Product Change Notification / KSRA-07GBXJ537

CCB 3546.002 Final Notice: Qualification of MTAI as an additional final test site for Atmel ATTiny414-SSF and ATTiny414-SSFR catalog part numbers (CPN) available in 14L SOIC package.

CCB 3546.002
Pre and Post Change Summary
PCN# KSRA-07GBXJ537

Packing Information –Tube

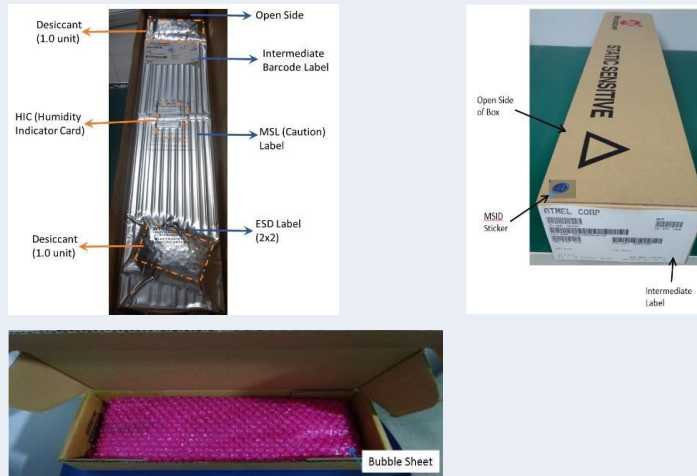
PRE CHANGE (MPHL)	POST CHANGE (MTAI)						
Final Test Location	Microchip Technology Operations (Philippines) Corporation /MPHL	Microchip Technology Thailand (HQ) / MTAI						
Packing Media	Tube	Tube						
Base Quantity Multiple (BQM)	56	57						
Pin 1 Orientation	<p>For SOIC</p> 	 <table border="1" data-bbox="1872 778 2497 906"> <thead> <tr> <th>Media</th> <th>Pin1 Side</th> <th>Opposite Side</th> </tr> </thead> <tbody> <tr> <td>TUBE</td> <td>White</td> <td>Black</td> </tr> </tbody> </table>	Media	Pin1 Side	Opposite Side	TUBE	White	Black
Media	Pin1 Side	Opposite Side						
TUBE	White	Black						
With Desiccant and HIC?	<p>1 unit Desiccant</p> 	Not Applicable

Carton Box

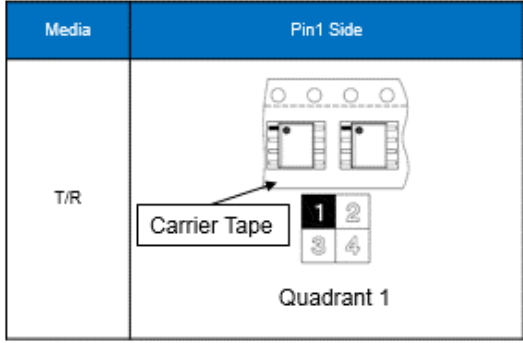
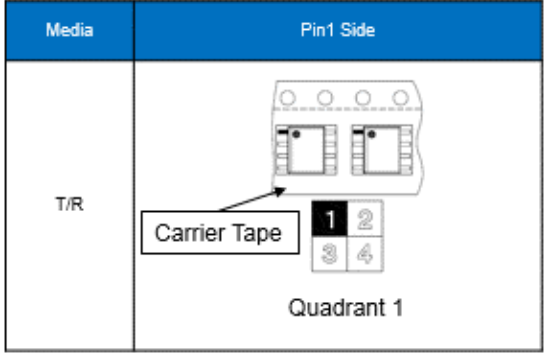
Length	Width	Height
560	130	78

Carton	Dimension W x L x H (cm)	Number of Bag/carton
M01-025 (C1)	15x64x5.5	1
M01-026 (C2)	15x64x10	2
M01-027 (C3)	15x64x14	3
M01-028 (C4)	28x63x11	4
M01-029 (C6)	28x63x15.5	6
M01-030 (C8)	28x63x20	8

Packing Information – Tape and Reel

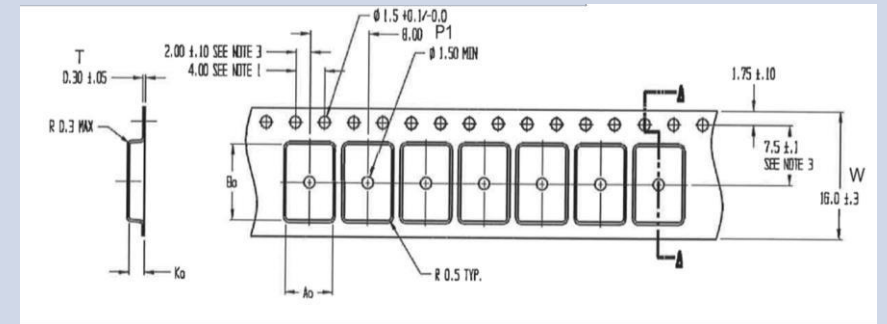
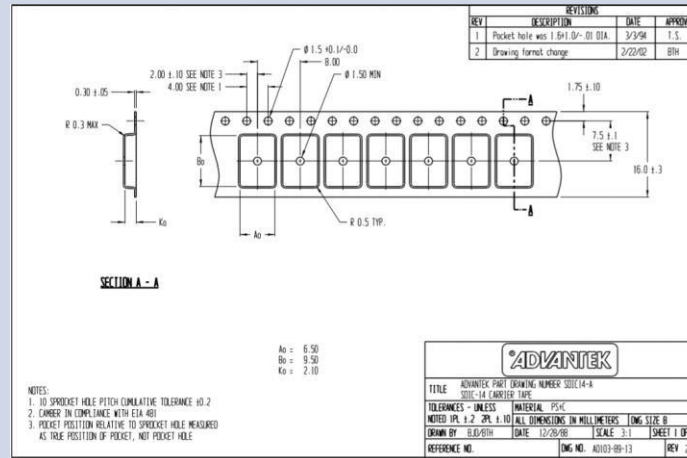
PRE CHANGE (MPHL)	POST CHANGE (MTAI)
Final Test Location	Microchip Technology Operations (Philippines) Corporation /MPHL	Microchip Technology Thailand (HQ) / MTAI
Packing Media	Tape and Reel	Tape and Reel
Base Quantity Multiple (BQM)	3000	3000
Pin 1 Orientation	Quadrant 1 	Quadrant 1 
With Desiccant and HIC?	1 unit Desiccant 	Not Applicable

Carrier Tape

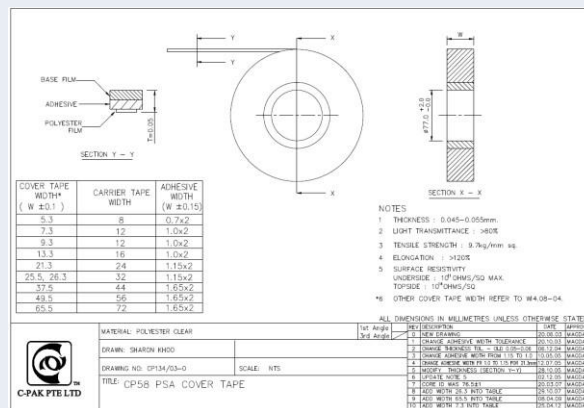
Mfg. Code	Mfg. Part No.	Microchip Part No.	Microchip Drawing No.	W (mm.) ± 0.3 or Specific	P (mm.) ± 0.1 or Specific	A ₀ ± 0.1 or Specific	B ₀ ± 0.1 or Specific	K ₀ ± 0.1 or Specific
AD	SOIC14-AC140.P1	22001406	B25-CT-092	16	8	6.50	9.50	2.10
CP	SO14NPS3 22X6NCL440 W16 (CL)	22001405	B25-CT-037	16	8	6.55	9.50	2.10
